15.3.9

15.7 RADIOLOGICAL EFFLUENT TECHNICAL SPECIFICATIONS (RETS)

15.7.2 SITE DESCRIPTION

This binder contains manuals that are either new or have been revised to contain material removed from RETS pursuant to GL 89-01 and GL 95-10. The following manuals are enclosed:

Figure 15.7.2-1

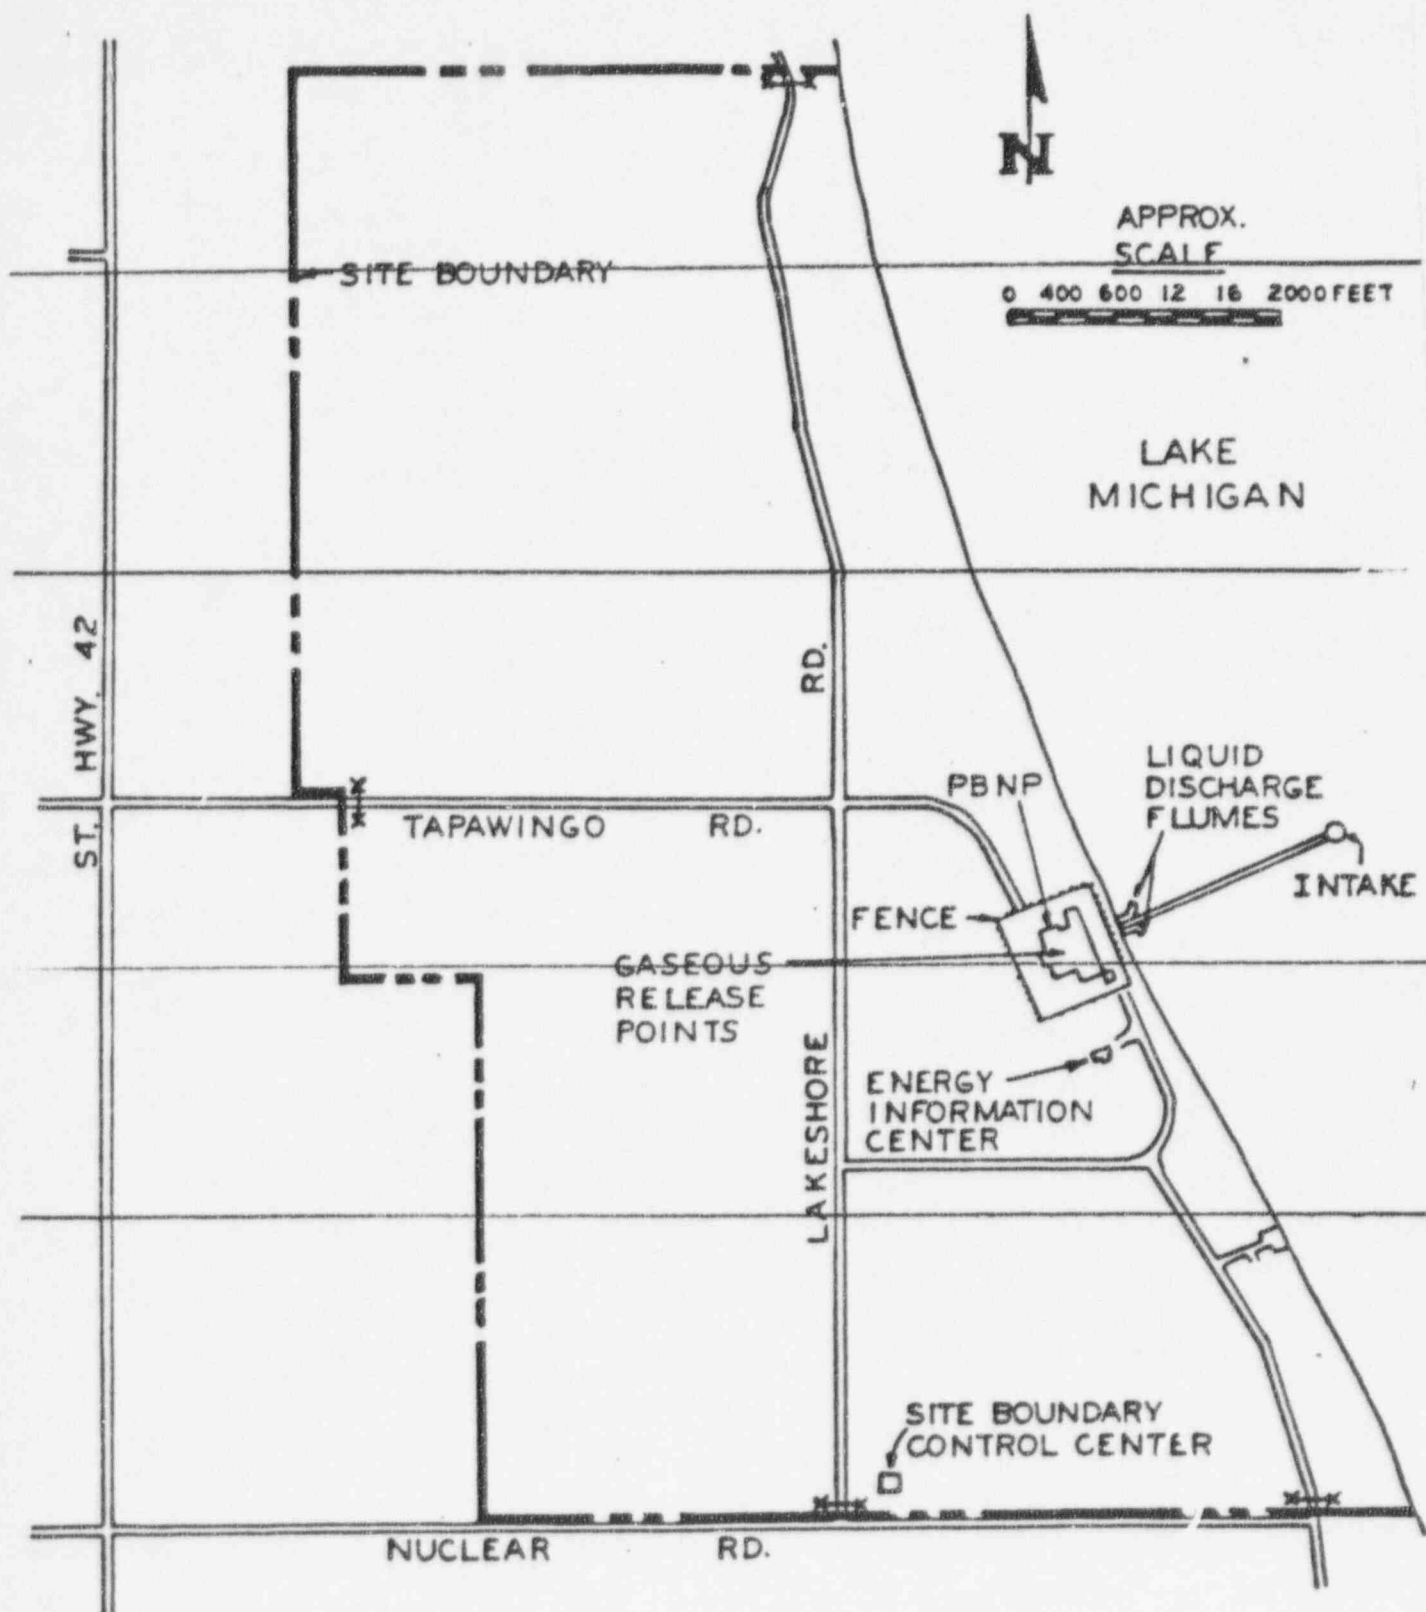
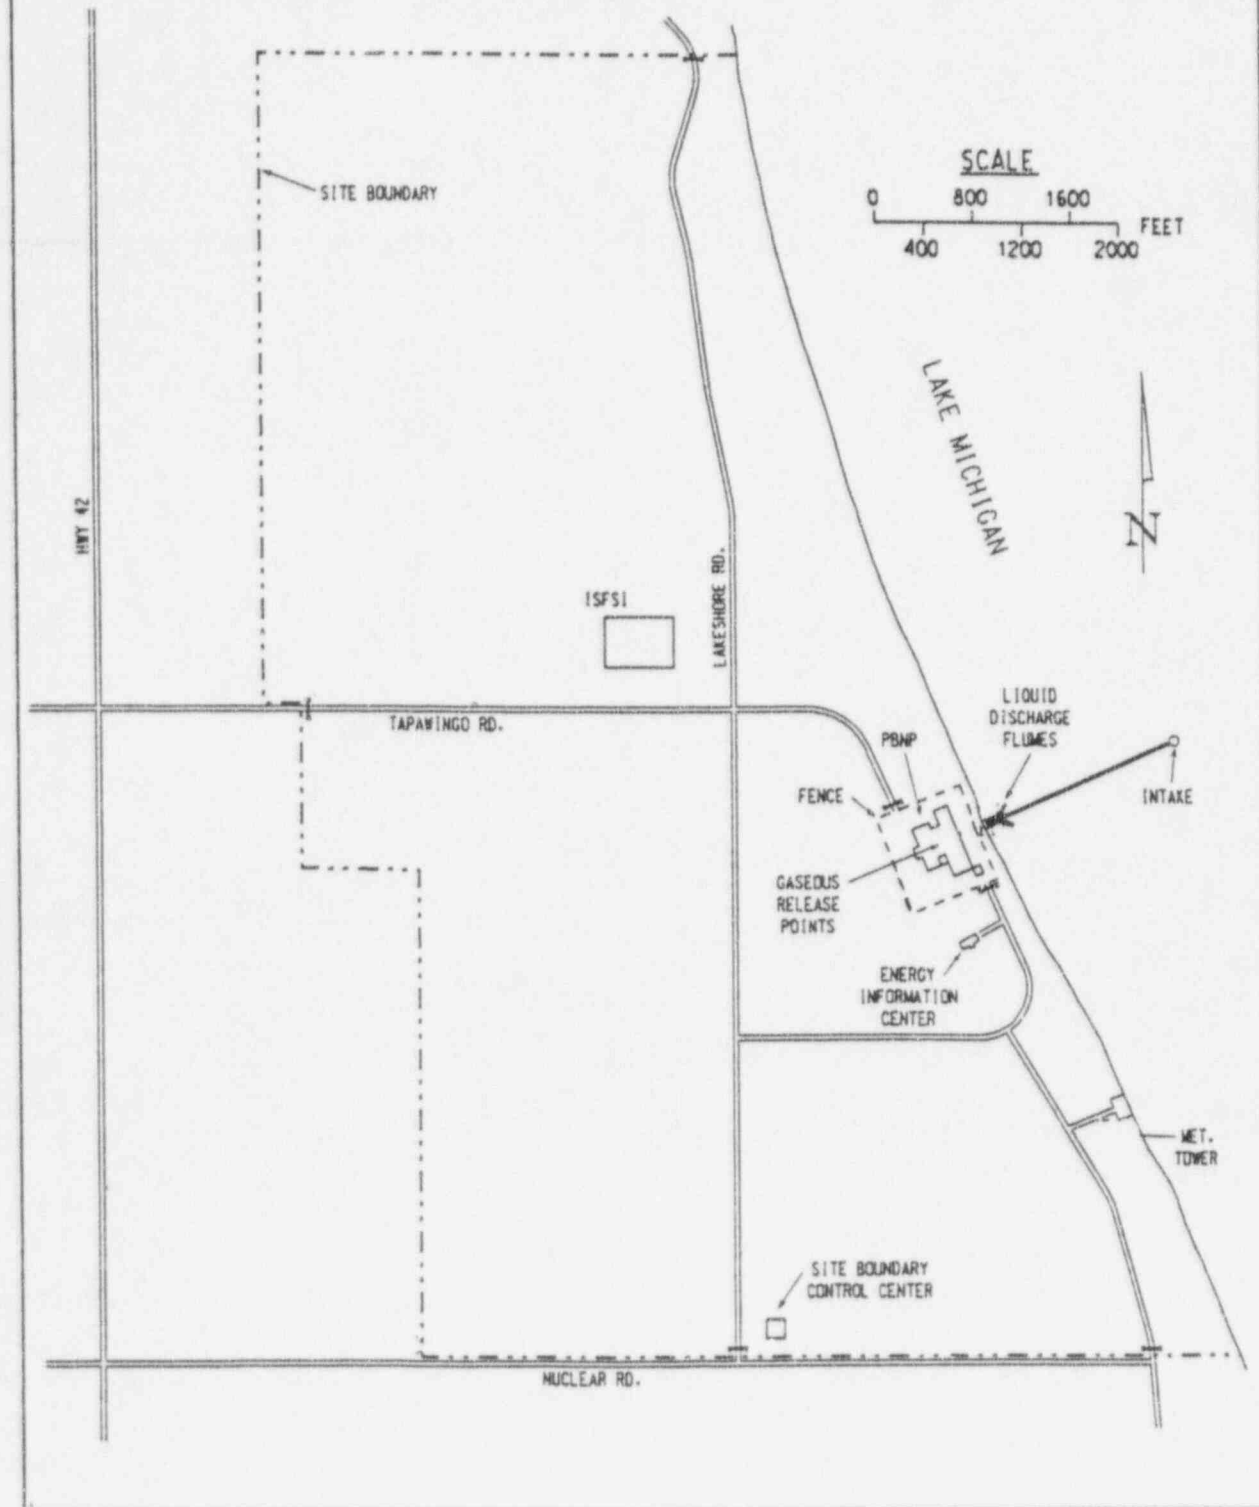
Figure 15.7.2-1 is a site map for the Point Beach Nuclear Plant Units 1 and 2. The site map shows the site boundary and points within the site boundary from which gaseous and liquid effluents are released. Fence locations are approximate.
